Subject: FW: O8W-PM Bucks Creek 1101 Phase 1,2&3 - Pre-Engineering Meeting You are listed as a contact in the scoping documents as someone that could work with the RR to determine the use of an existing transformer...can you provide me with your contact at the RR? Please advise, Project Manager Office: Mobile: **Email:** Pacific Gas and Electric Company From Sent: Tuesday, February 23, 2021 11:29 AM To: Cc: <<u>JDBe@pge.com</u>>; Fuchs, Christopher <<u>CJF8@pge.com</u>> Subject: O8W-PM Bucks Creek 1101 Phase 1,2&3 - Pre-Engineering Meeting All, Good meeting yesterday... I feel its best to get everything 'on the table' as soon as possible in the 'life cycle' of any project, here is that attempt. I will set up a virtual 'follow up' meeting next week to discuss who is taking what action items below.....first I need confirmation that we can even change scope, and what the process looks like. Here are my notes/action items: PM (Phase 1) 1. We learned the following: is undergoing its own project under PM a. Sub-Station (per Foremar

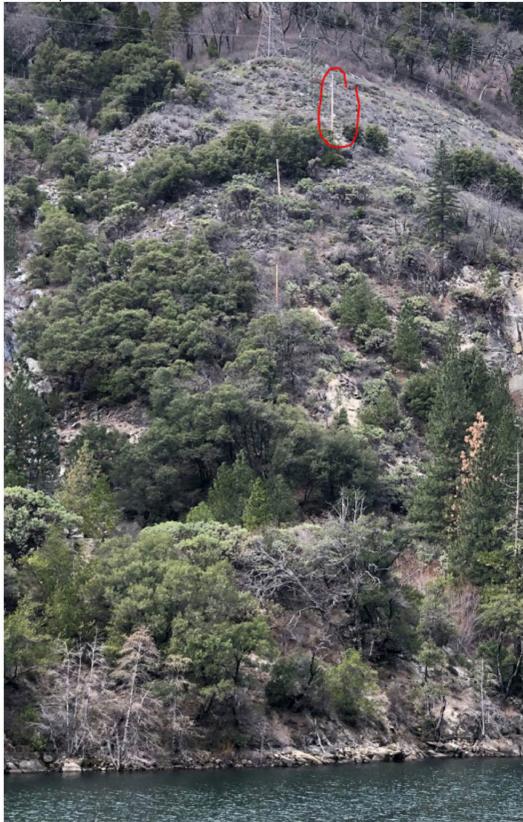
(Phase 3)1. RR Siding Service/Tx located in picture below also has a weather station on pole and scope for

replacing this Tx is another 'what if' scenario of:

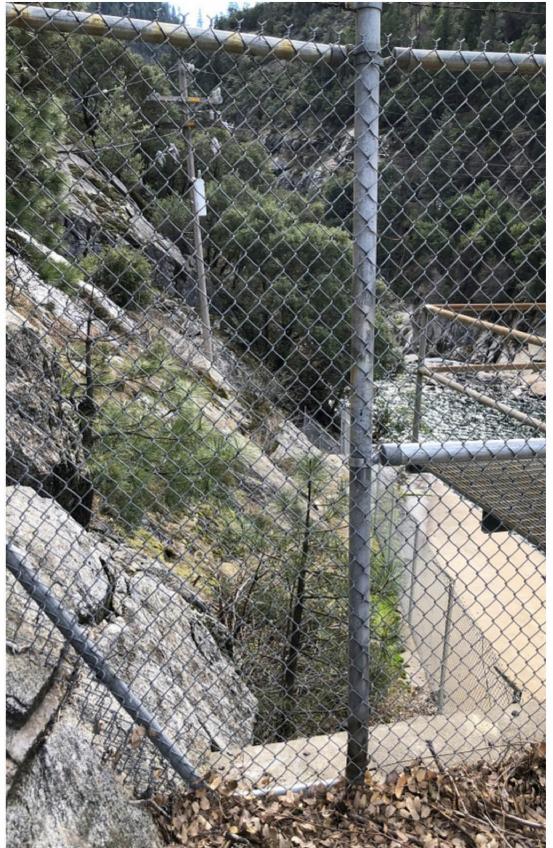
- a. Does the RR need the service?
- b. If they do can we serve via a crossing at the Cresta Dam.
- c. If Cresta Dam doesn't work should we cross the river a different location?
- d. What do we do about the weather station?
- e. Here is pic:
